Section: XII (Bulletins)

Number: 68-467-14

Date : 9/20/67

A. MerCruiser Engine Alignment - 4 & 6-Cyl. (P. 9A, Sec. 11)

Engine Alignment Shaft

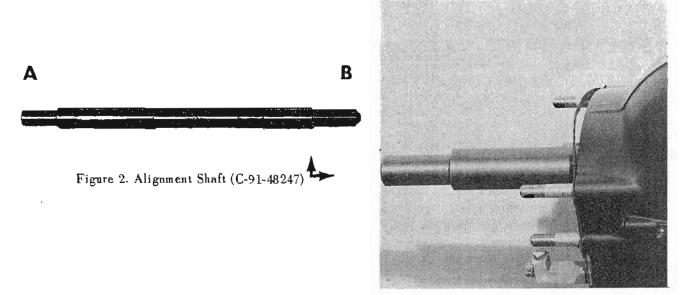
When using new Alignment Shaft (C-91-48247), disregard the nine (9) inch (23cm) alignment rod, which is shipped with the engine, and proceed as follows:

- 1. Shift engine into forward gear.
- 2. Remove 6 cap screws or elastic stop nuts which secure stern drive unit to bell housing and fasteners which hold Dyna-Shocks and/or trim or tilt cylinders to drive shaft housing.
- 3. Remove stern drive unit.
- 4. Check engine serial number. Modify split washer (B-13-33734) where necessary, as stated in preceding discussion (Paragraph "A"). (Figure 1)
- 5. Place Alignment Shaft (C-91-48247) end "A" thru gimbal bearing in gimbal housing and into engine coupler spline. (Figure 2) If alignment shaft enters coupling freely with no pressure, alignment is correct. If not, proceed as in Paragraph "6", following.
- 6. Loosen front mounting bracket adjusting nuts and thread either way to raise or lower front of engine until alignment shaft slides into engine coupler spline with no pressure.

- 7. Tighten adjusting nuts securely after alignment is complete.
- 8. Place heavy coating of Multipurpose Lubricant (C-92-35226) (if not available, use a heavy-duty wheel bearing grease) on splines of coupling and universal shaft.
- 9. Replace stern drive unit, Dyna-Shocks, and trim or tilt cylinders, if used.
